RE: **Mountain Subdivision**
2406 Mountain Rd NW
Grading Plan Engineer's Stamp Date: 1/12/18
Drainage File: J13D207

RE: **Mountain Subdivision**
2406 Mountain Rd NW
Grading Plan Engineer's Stamp Date: 1/8/18
Drainage File: J13D207

ENGINEER'S SEAL	2406 MOUNTAIN ROAD	DRAWN BY WCVJ
DAVID SOULE NEW MEXICO REGISTERED PROFESSIONAL ENGINEER 1/12/18	GRADING AND DRAINAGE PLAN	DATE 1-07-17
DAVID SOULE P.E. #14522	Rio Grande Engineering 1606 CENTRAL AVENUE SE SUITE 201 ALBUQUERQUE, NM 87106 (505) 872-5998	21842-LAYOUT-1-07-18
		SHEET #
		JOB # 21842

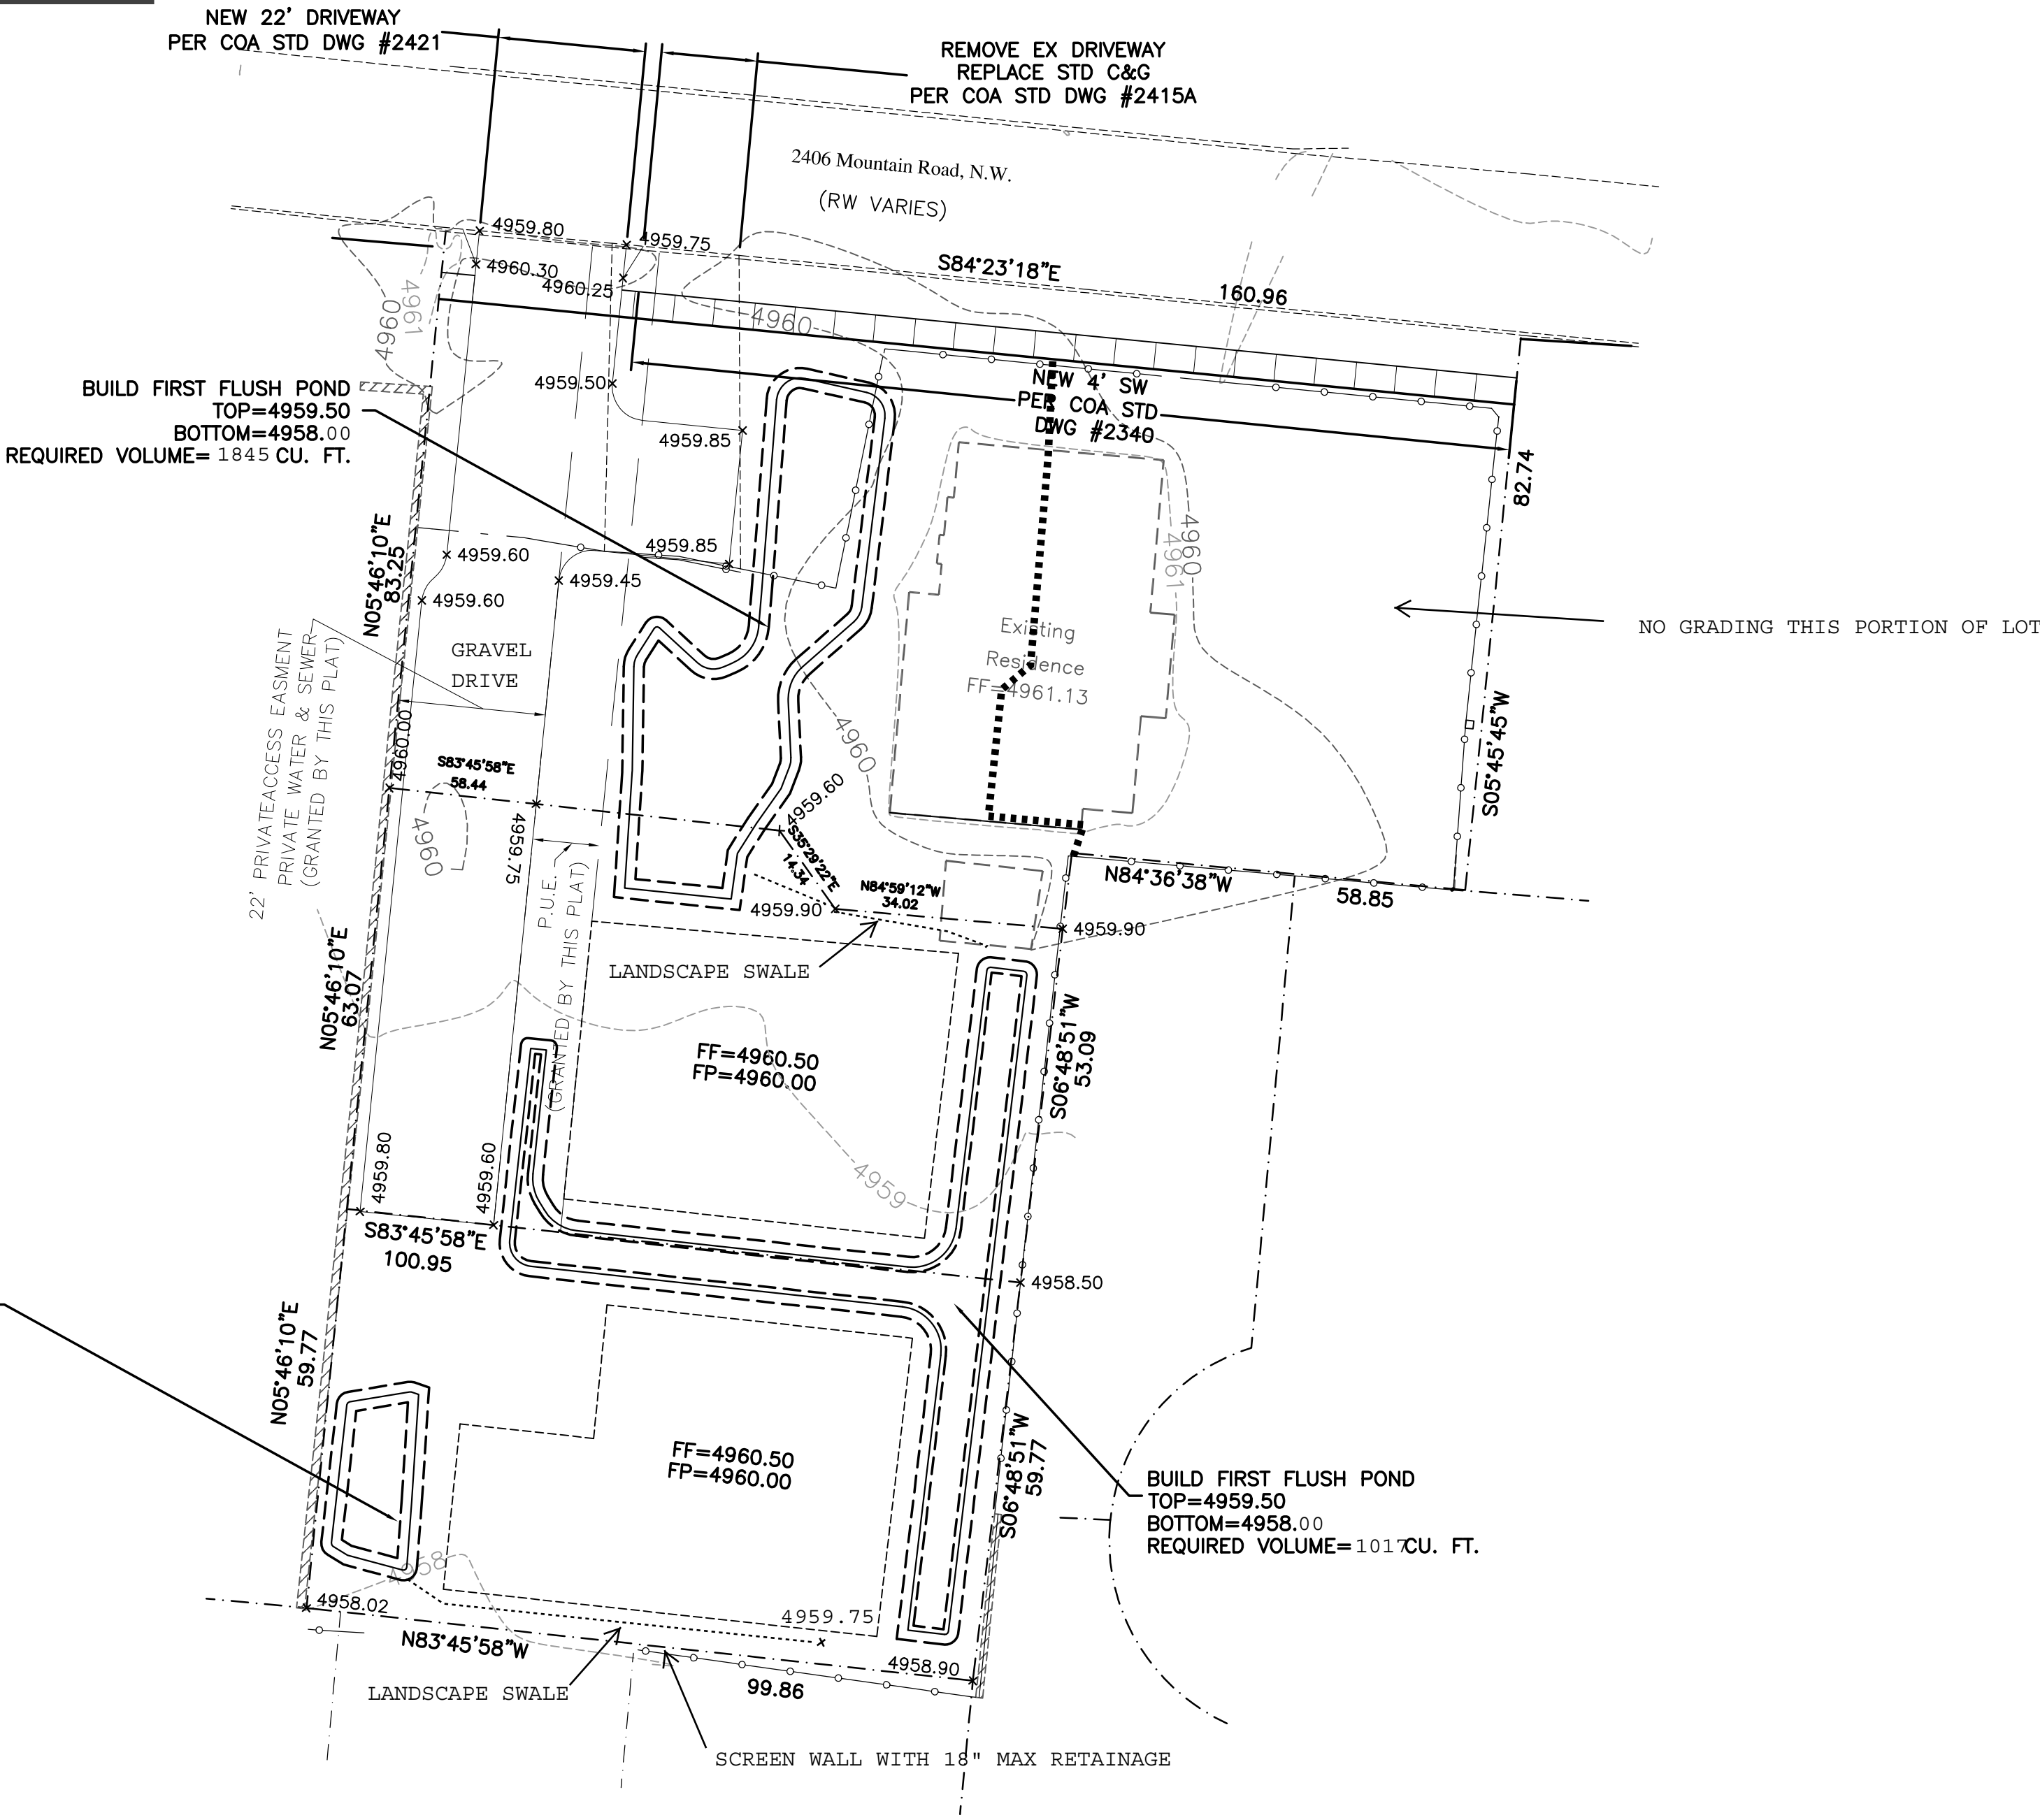
Based on the information provided in your submittal received 1/10/18, the Grading Plan cannot be approved until the following are addressed.

1. Provide onsite ponding volume on each lot for the 100-year, 10day volume; infiltration rates cannot be accepted in lieu of this volume requirement. **UPDATED TO 10-DAY**
2. Please add swales along the side yards to direct runoff into the ponds. **ADDED**
3. Ensure that the Preliminary Plat includes cross lot drainage easements identifying maintenance and beneficiary responsibilities to support the ponds crossing the lot lines. **CONFIRMED IT WILL BE ON PLAT**
